R.C.A. Victor Co., Inc.

Model: 25X

CHANGES, NOTES

RCA MFG. CO., INC.

"PM" Speaker 92388-1:

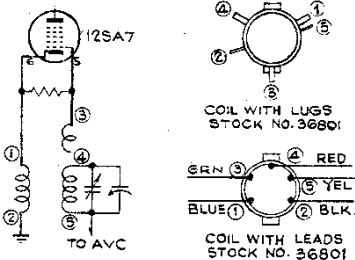
The cone and voice coil for this speaker is Stock No. 39572.

Crystal Pickup Connections, QU51C

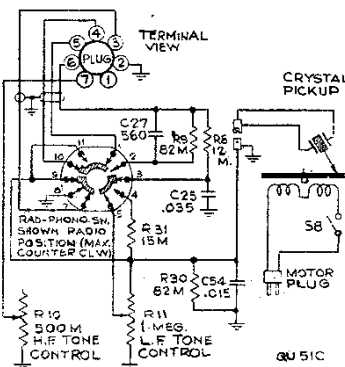
The schematic "Crystal Pickup Connections (QU51C)" in the QU51C service note is in error in the connections to switch terminals 7, 9, and 11. The correct schematic is shown in the accompanying sketch.
